C 27 PREAMPLIFIER

SERVICE INFORMATION

SERVICE BULLETIN

REDUCE RFI & ELIMINATE OSCILLATION

MAIN PC BOARD 045250

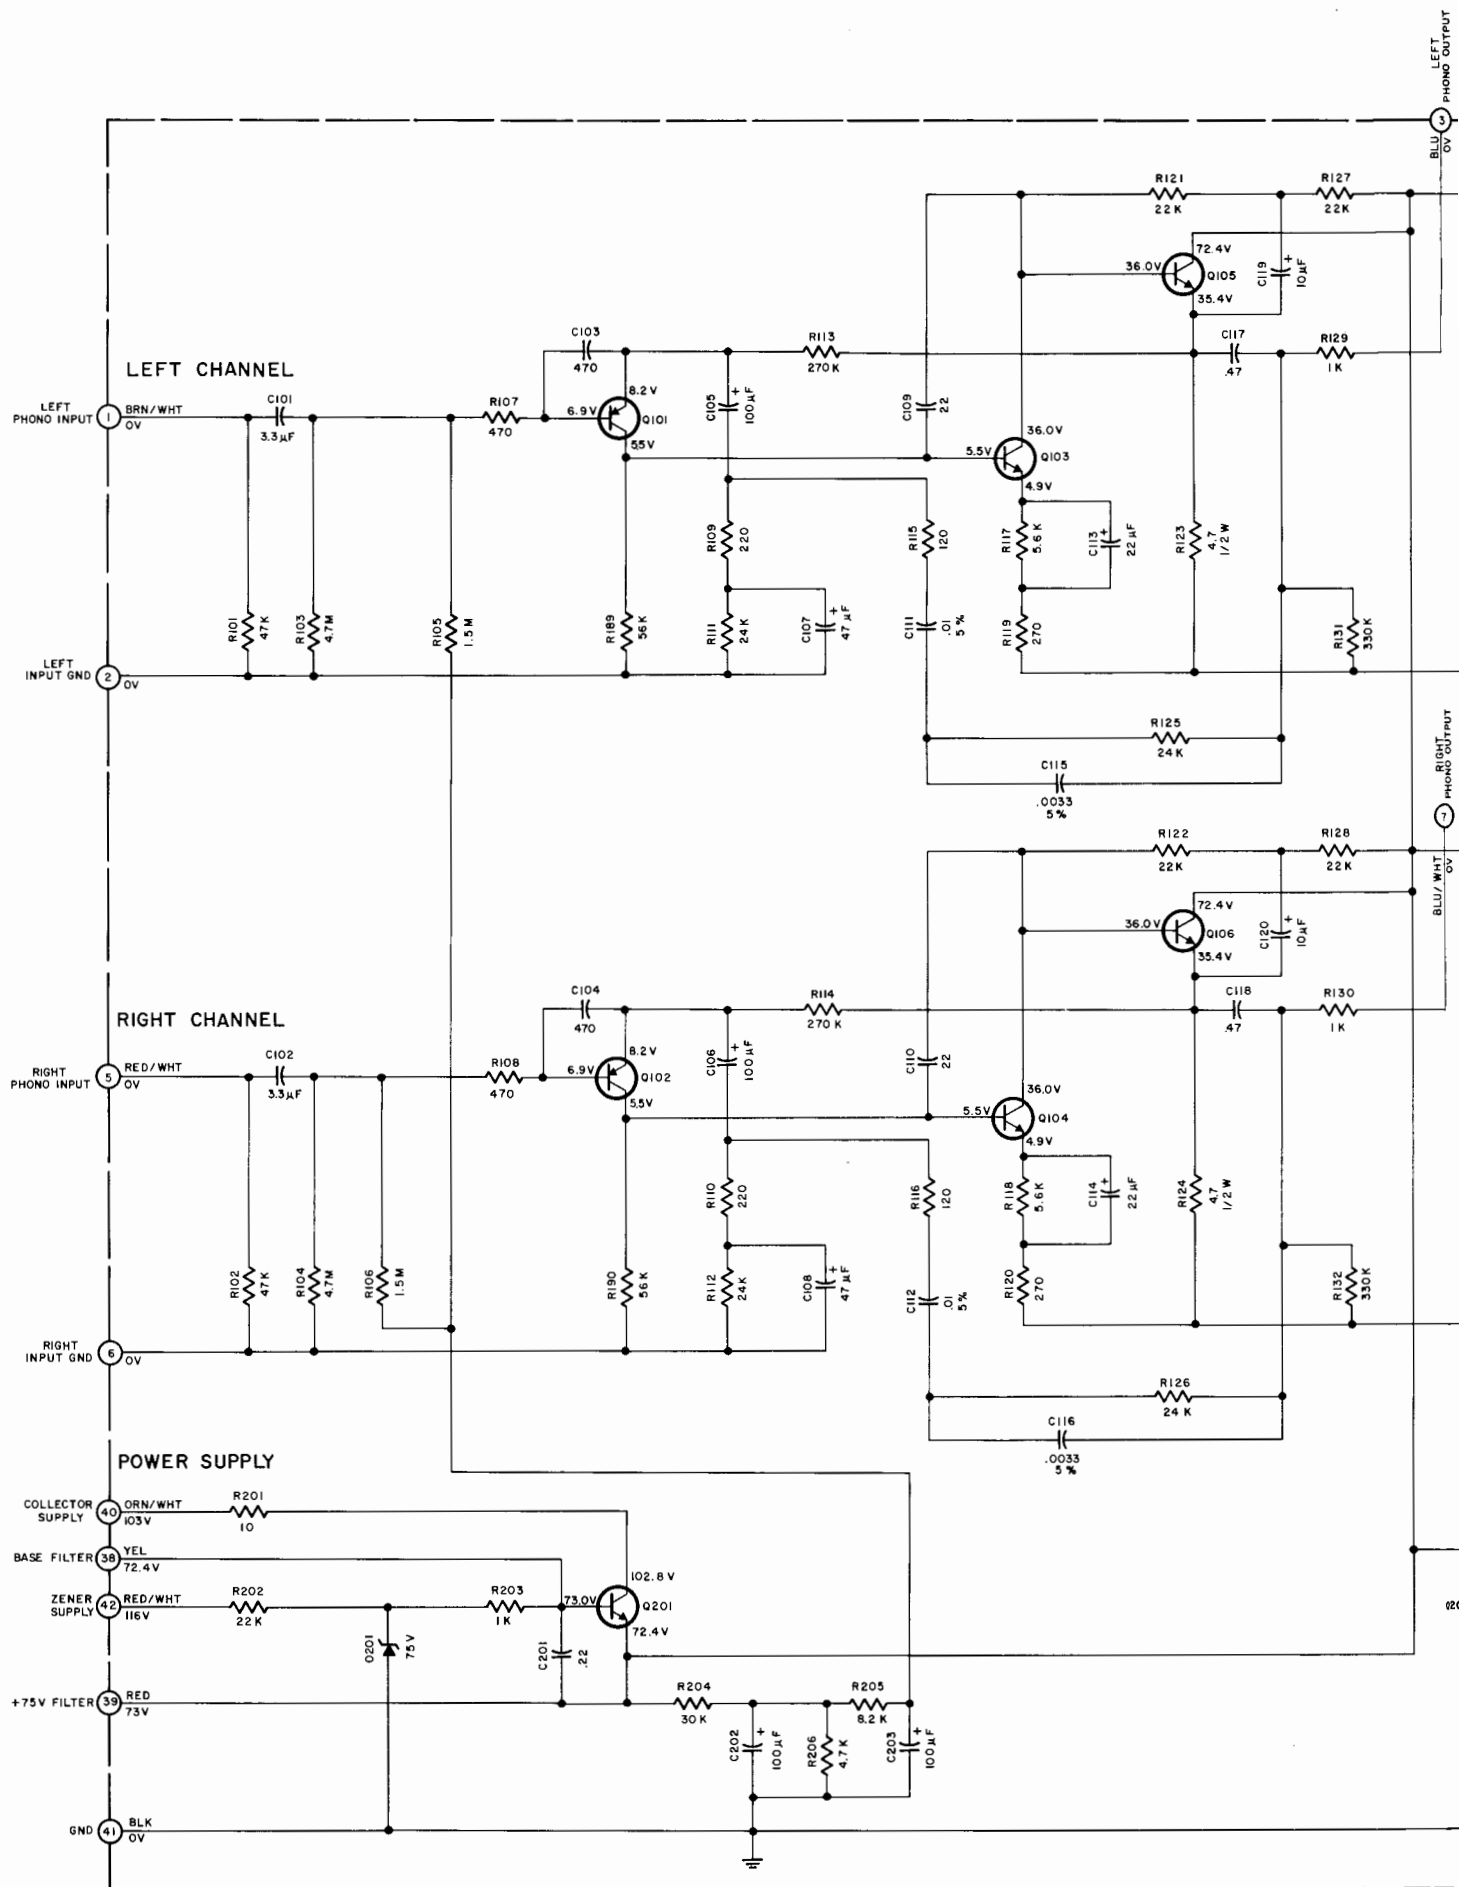
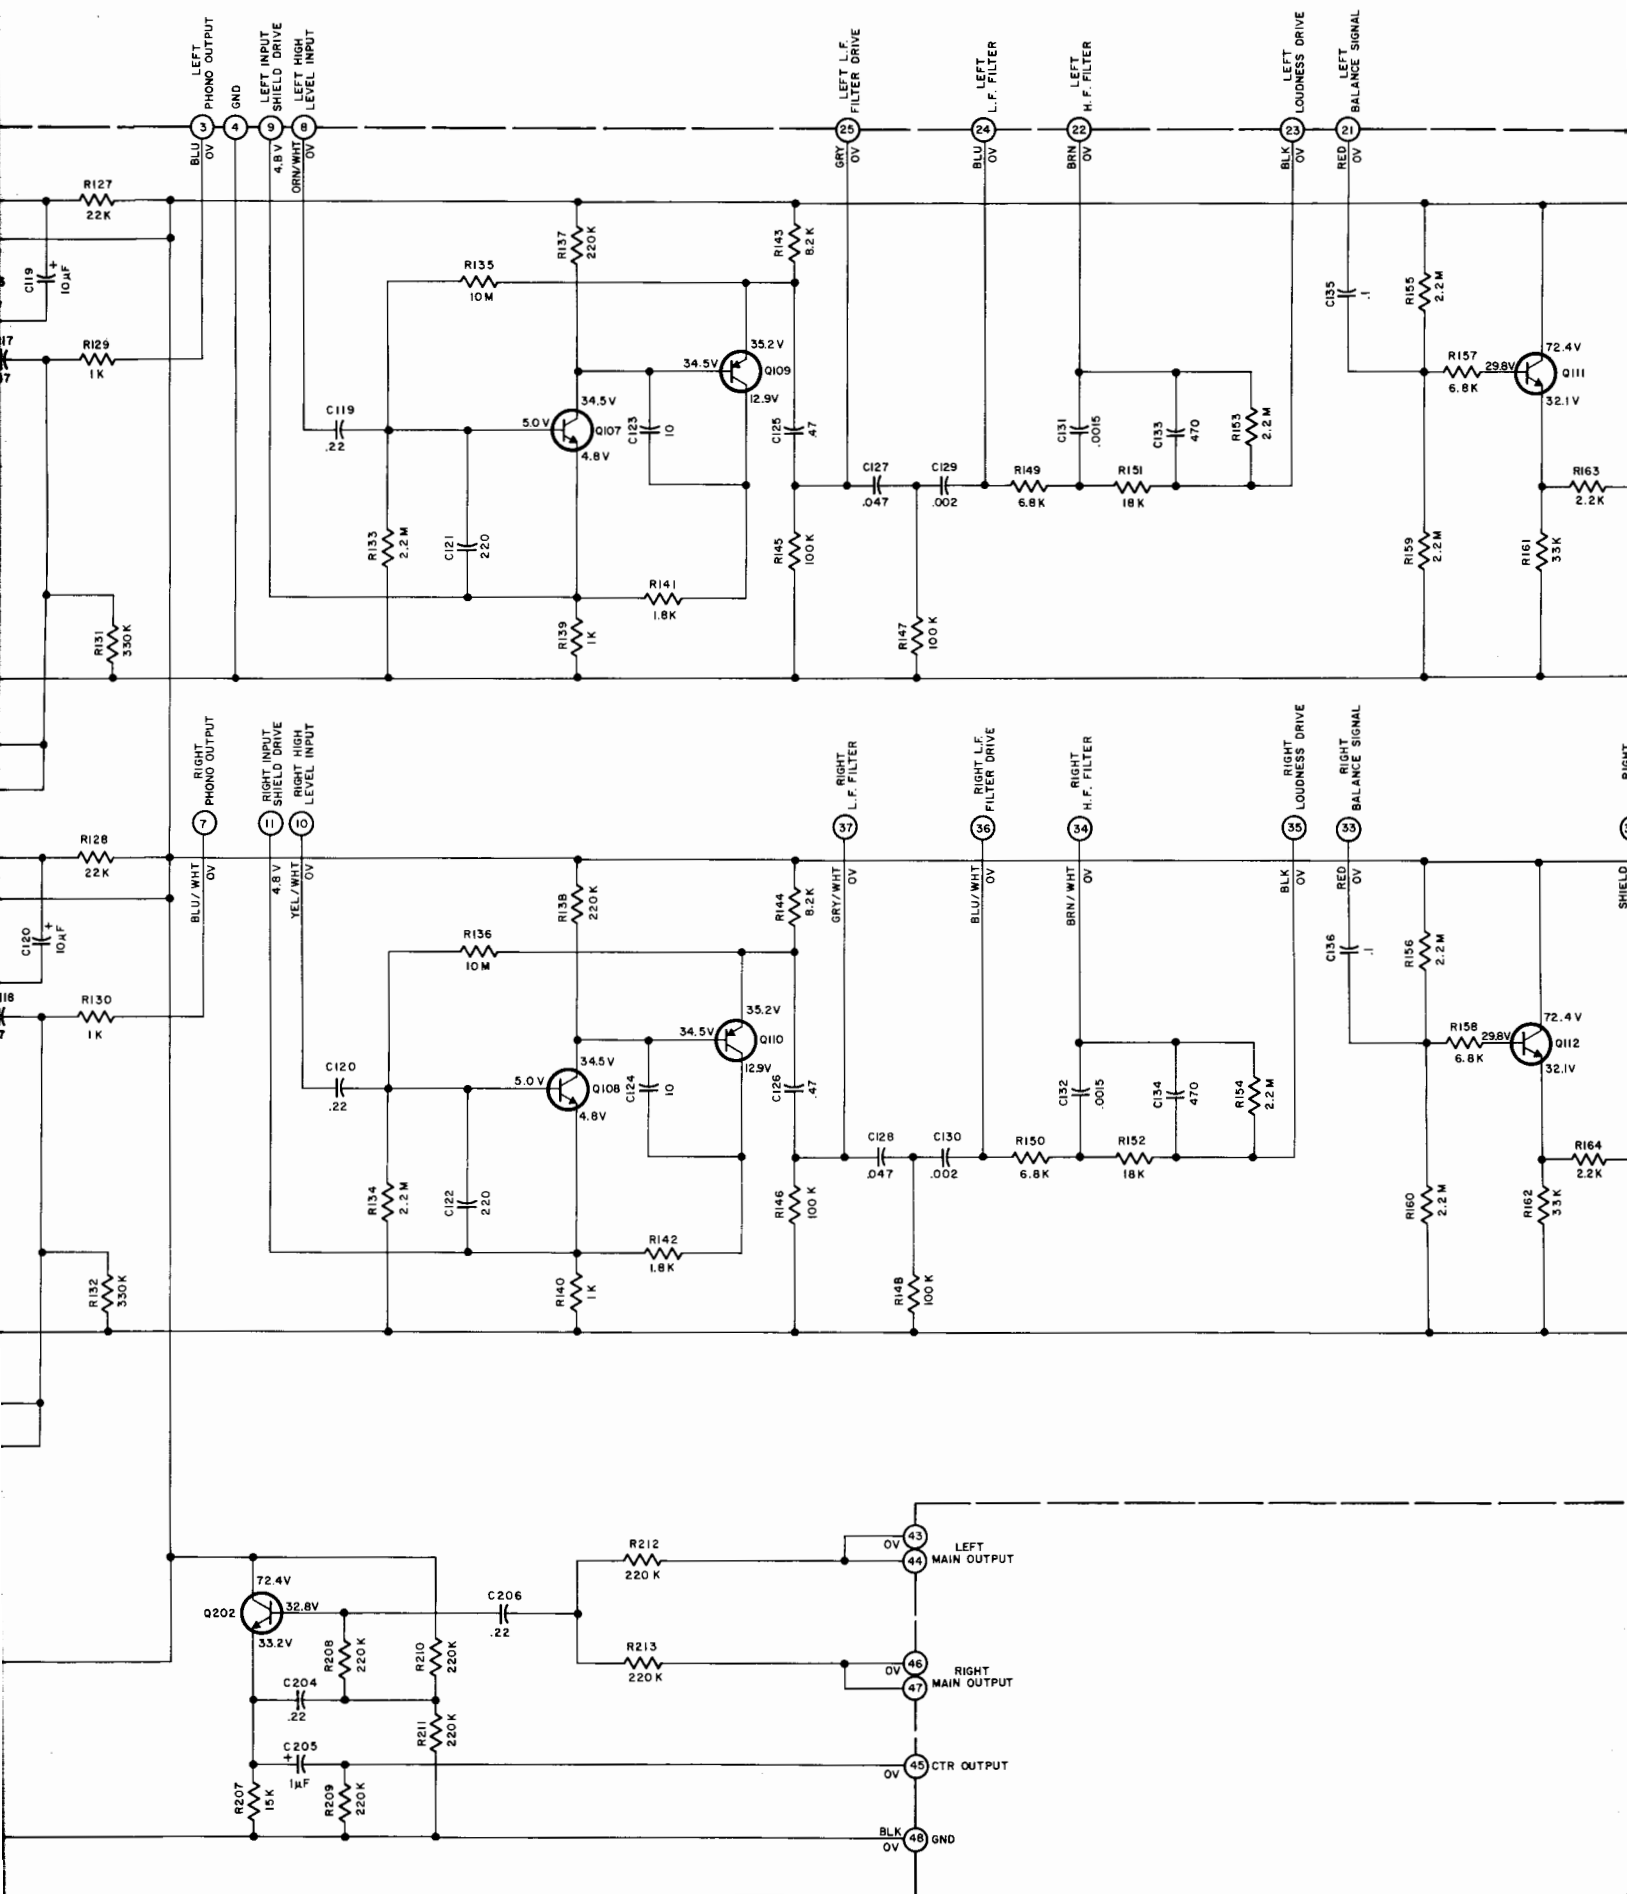
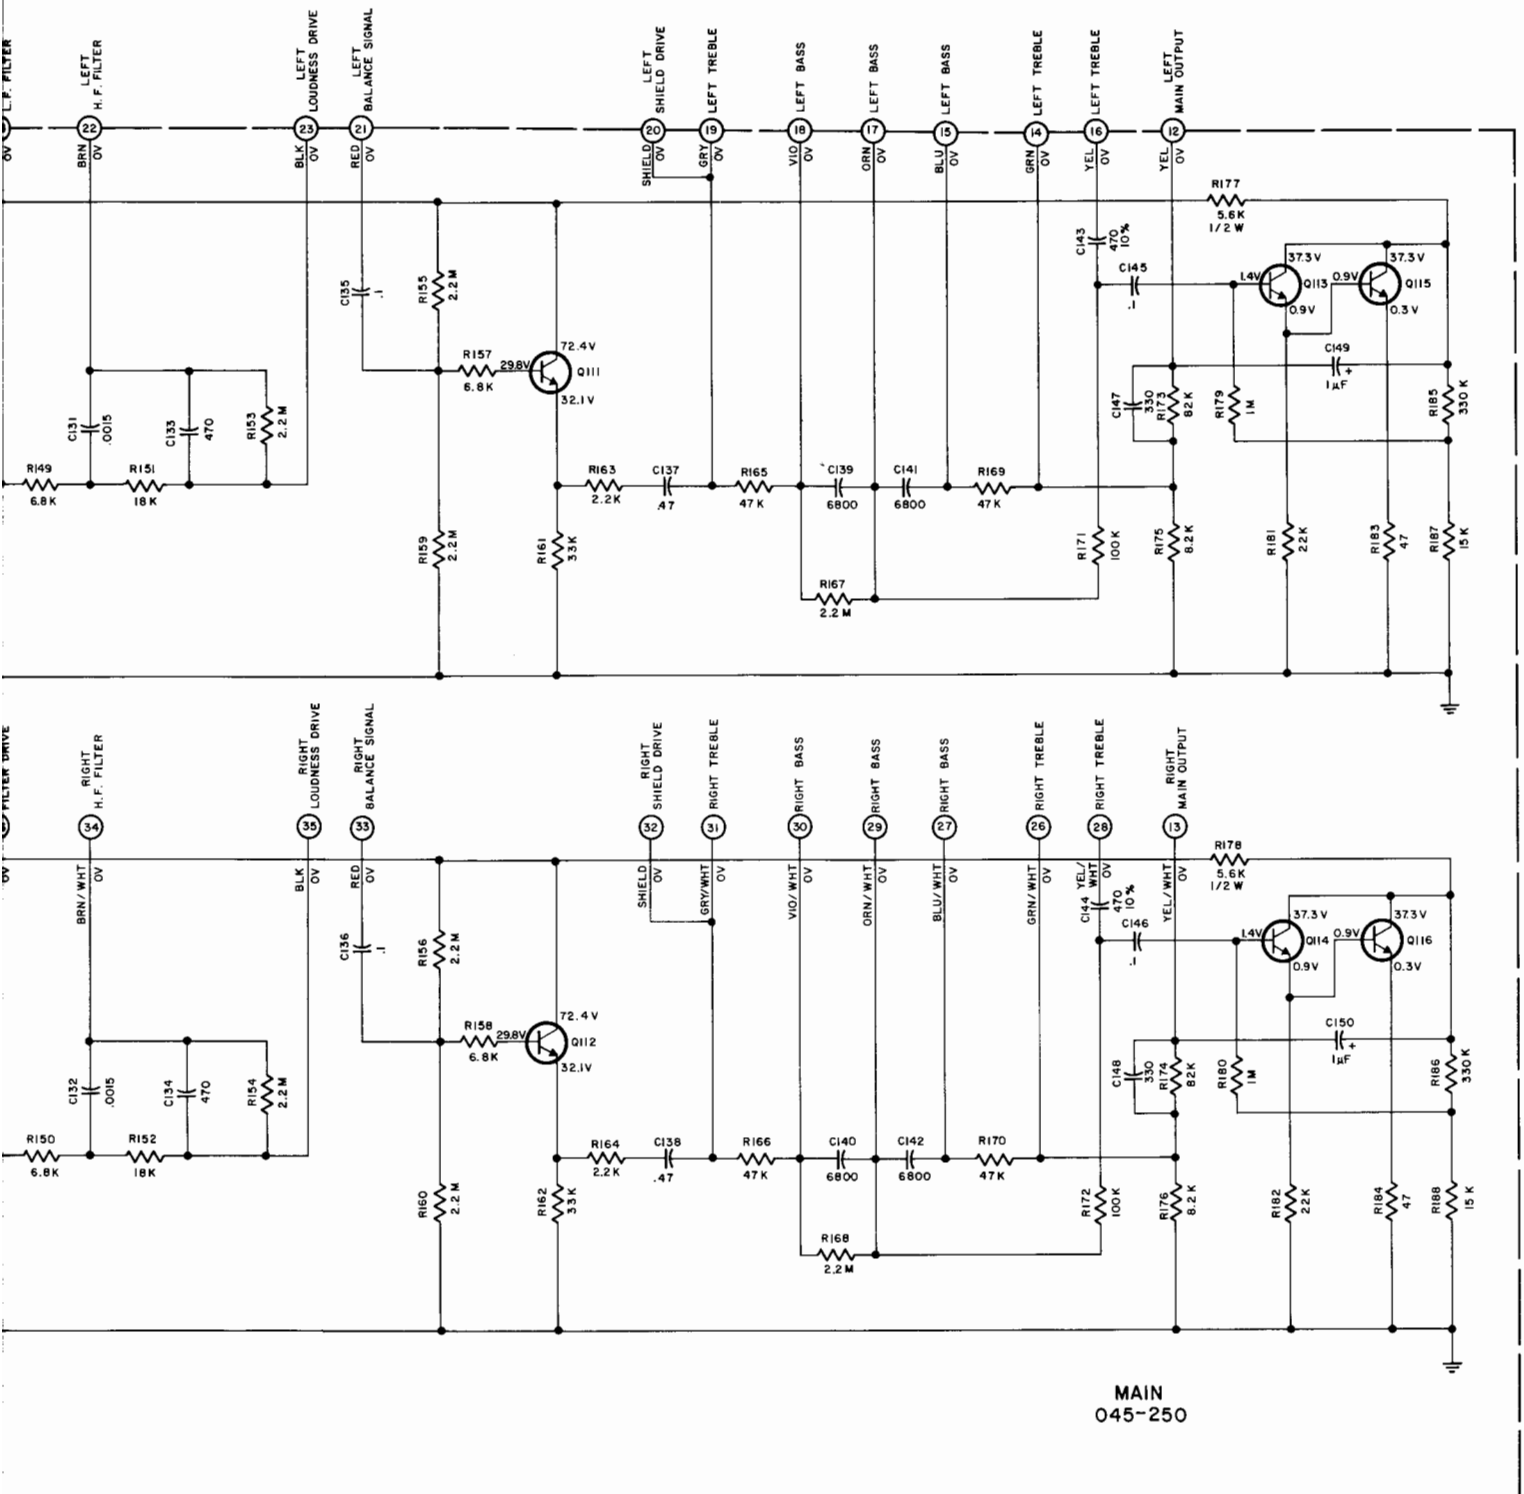
PURPOSE OF MODIFICATION: To reduce sensitivity to RF interference and to eliminate oscillation when using a moving coil phono cartridge.

- A. Undersired reception of CB, ham apparatus and man made noise in the phono mode.
- B. Oscillations, when a moving coil cartridge is used.

PROCEDURE: All changes are on the main PC board (045250), except step 4.

1. Change C103 and C104 from 470pF 10% to .003 μ F 20%
2. Remove and replace R115 and R116, 120 Ω , 5%, 1/4W with wire jumpers.
3. Locate capacitor C109, Disconnect the lead on C109 that connects to R121. Connect a 56K, 5%, 1/4W resistor in series with the disconnected C109 lead and the circuit board where the C109 lead formerly connected. Do likewise for capacitor C110.
4. Connect right at the phono jacks a film resistor = 470 Ω , 5%, 1/4W in series with the leads connected to these phono jacks.
